SEWAGE DISPOSAL SYSTEM

HOWARD COUNTY HEALTH DEPARTMENT

SUBDIVISION Warfield Estates LOT 8, Blk. B, Sec. 3 ROAD 3432 Shady Lane

PROPERTY OWNER Stephanie Brown

INDICATE NORTH - NAME ADJOINING ROADWAY AS BASE LINE Shady Lane

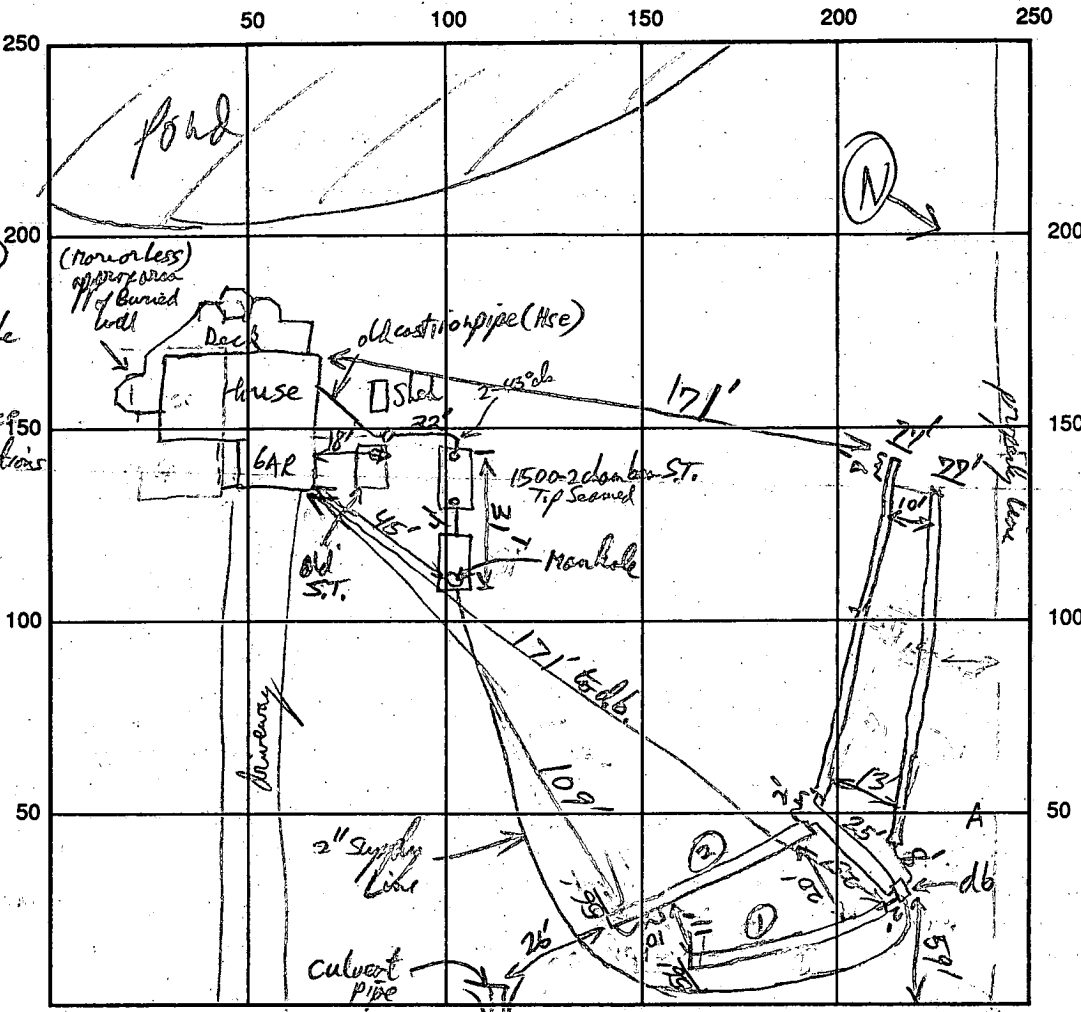
Replace existing Septic Tank with a top seamed septic tank (2 compartment preferred). Install Trenches on Contour in both directions away from a central Distribution Box Placed approximately near the North East corner of the lot. (as discussed 4 Trenches, 70' long each is acceptable. Make in lot 3' deep, Bottom of Trench 5' deep maximum, 3 ft wide trenches, 2' gravel fill.

Excavation @ Pump Chamber bottom soil is a course sandy loam with concrete small diameter (cid) Jam connections. Indicates some seasonal water table problems @ 6-7ft below ground surface at S.T. + P.C locations near house.

REMARKS: Trench #1 entire length Bottom, just penetrating into sandy loam soils, ~75% of Trench has 1-1 1/2 ft effective sidewall of this similar material. Hse connection dis connected From old S.T. Pump Chamber + New Septic Tank OK to cover. OK to cover Trench #1 RPP 8/11/93 Used 2" supply pipe (Flows Pump Check OK. All Trenches penetrate into loam/sandy loam soils OK to cover RPP 8/12/93 (125 gal dose)

LINEAR FEET OF TRENCH REQUIRED 280' (266' F accepted to keep distance from culvert & stormwater runoff) R/P 8/1/93

INDICATE NORTH - NAME ADJOINING ROADWAY AS BASE LINE
 SHADY LANE

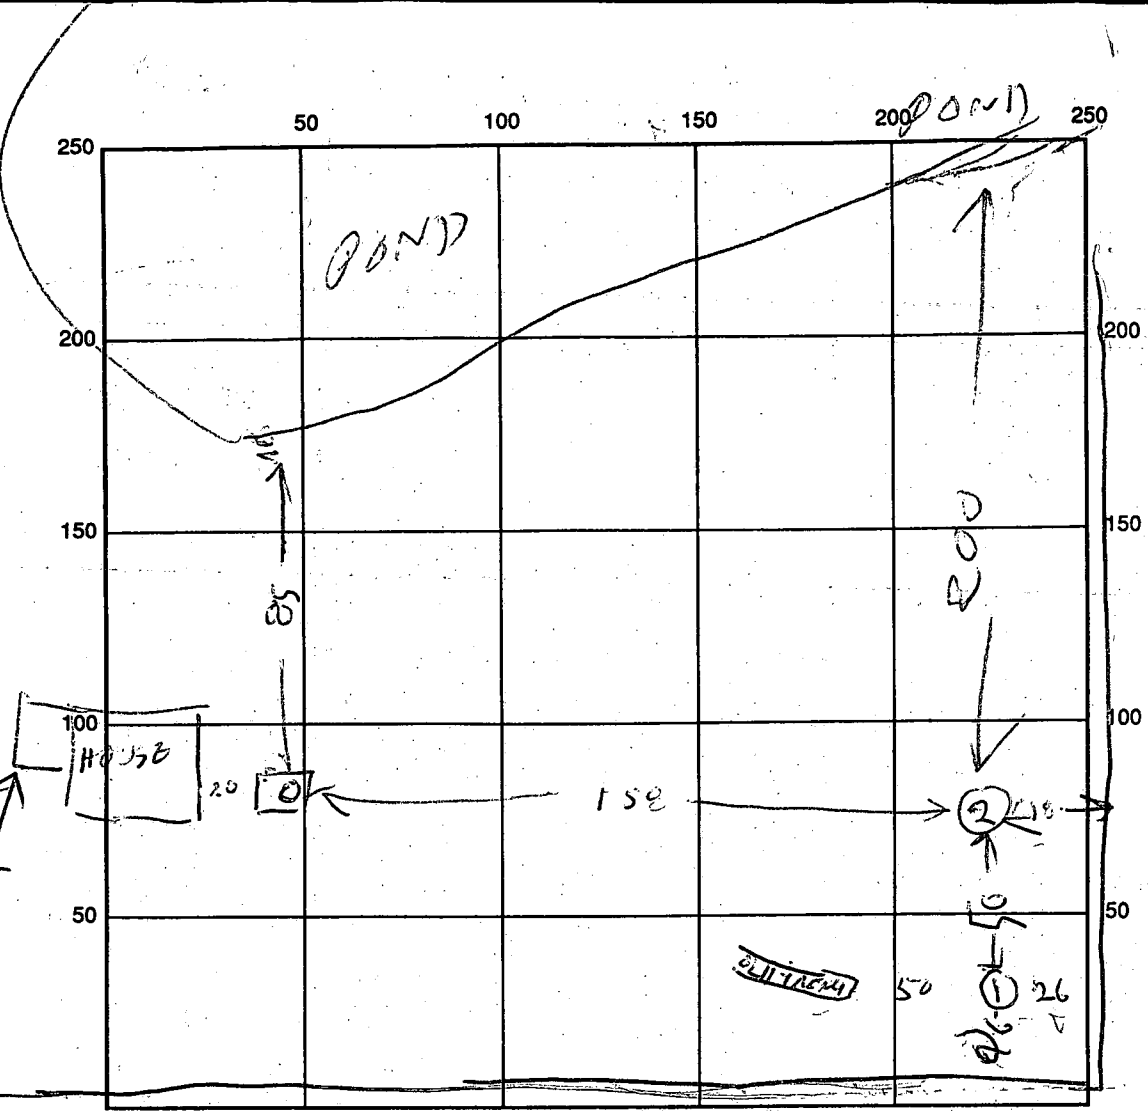
*2/18/91 - CONTACTED BY SEPTIC CONTRACTOR. POND WAS INSTALLED AFTER HOUSE BUILT, CERTAIN
IMPACT IN GROUND WATER TABLE. HIGHEST AVAILABLE GROUND ON PROPERTY IS ACCESS
EASEMENT TO COMMUNITY POND. LOT OWNER WILL ATTEMPT TO ARRANGE APPROVAL
TO UTILIZE THIS ALSO. C. Williams*

REMARKS: 2/15/91 - PERC UNSATISFACTORY FOR REPAIR
HOME OWNER INSTALLED BASEMENT TOILET 3 YEARS AGO
& WATER COMES UP IN TOILET DURING WET SEASON R#

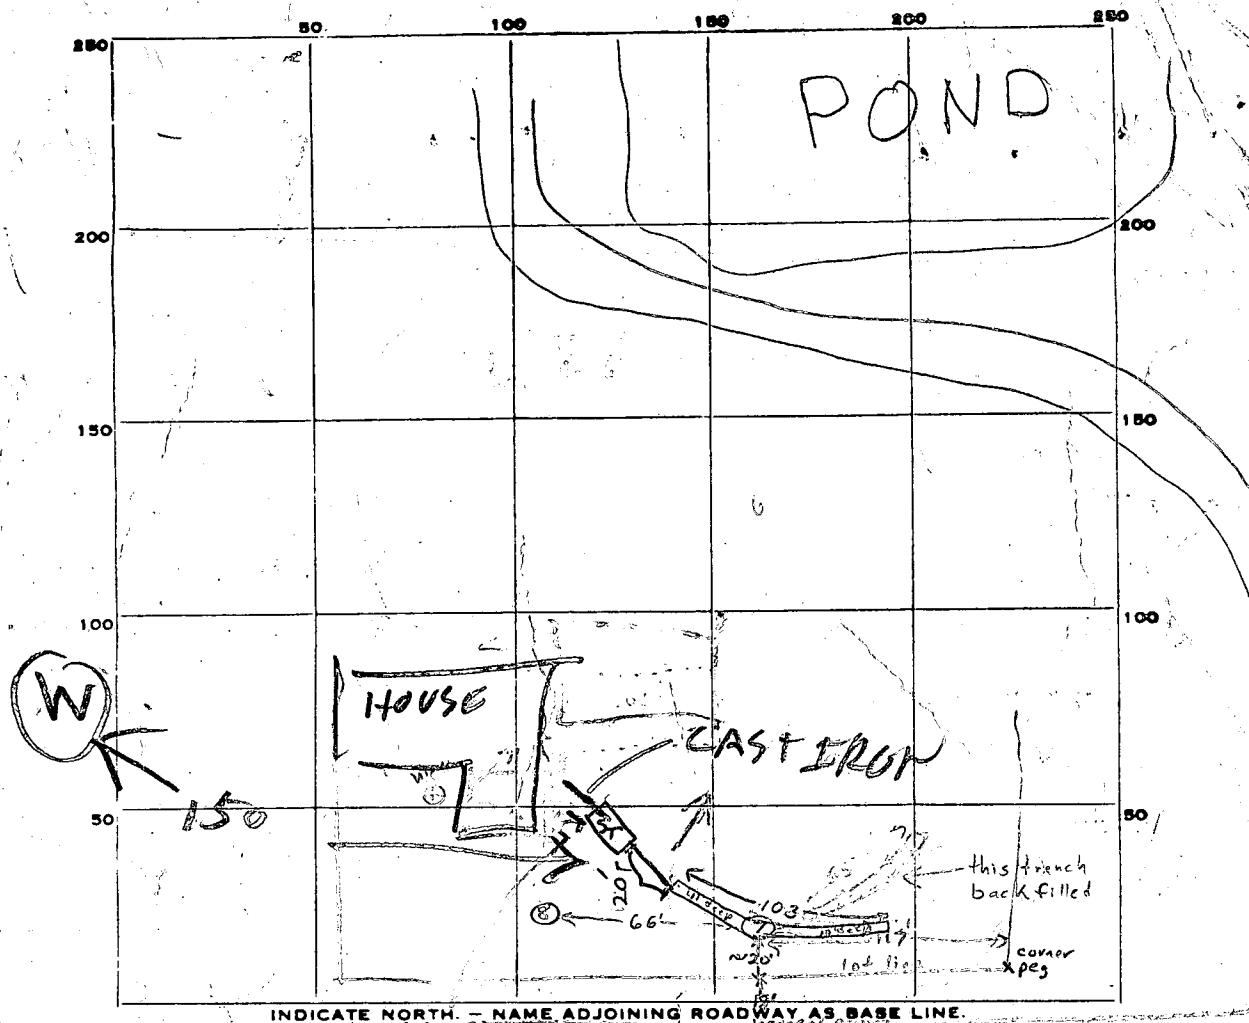
TENTATIVE: pending check of holes, due to well in septic area. 90 ft. trench, 10 ft. maximum depth, effective 4 ft. - 10 ft. in lieu of 400 sq. ft. drywell inlet maximum 4 ft. Location: in area between 30 ft. and 60 ft. from road depending on holes being acceptable.

REMARKS 4/4/78 Mrs. Daniel present, proposed trench to go in area shown above F.S. & L.
4/5/78 Water at 9' in fore end of trench, no one onsite. T.C. & Mrs. Oundarceval relocation
of trench owner to return call F.S. 4/6/78 trench backfilled, new trench
is shown above O.K. hole dug at far end of trench to 13' and was dry, F.S. & L. S.
4/6/78 O.K. to put gravel in trench F.S. 4/7/78 Gravel to 4 FE below grade. OKAY to Back fill
over trench and Dry well. Told Cleanout should be even with final Grade.
Still not connected to house 4/7/78 MB.

INDICATE NORTH. - NAME ADJOINING ROADWAY AS BASE LINE.

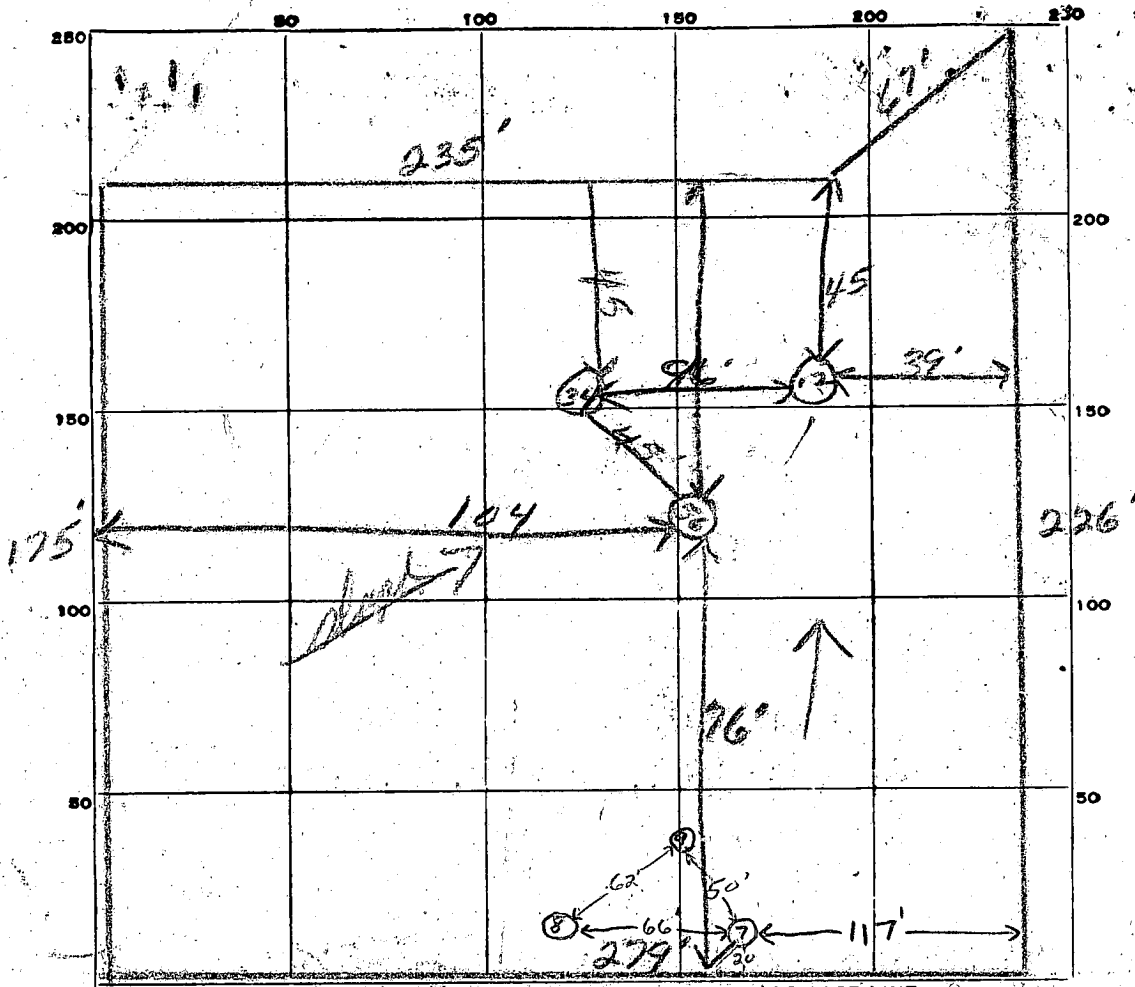
Dry Well inlet to be no deeper than 4 FT and bottom of Dry Well to be no deeper than 10 FT below org. grade
Place the dry well 100 FT from the front lot line and 20 FT from the left side of the lot as seen when facing the lot from Shady Lane
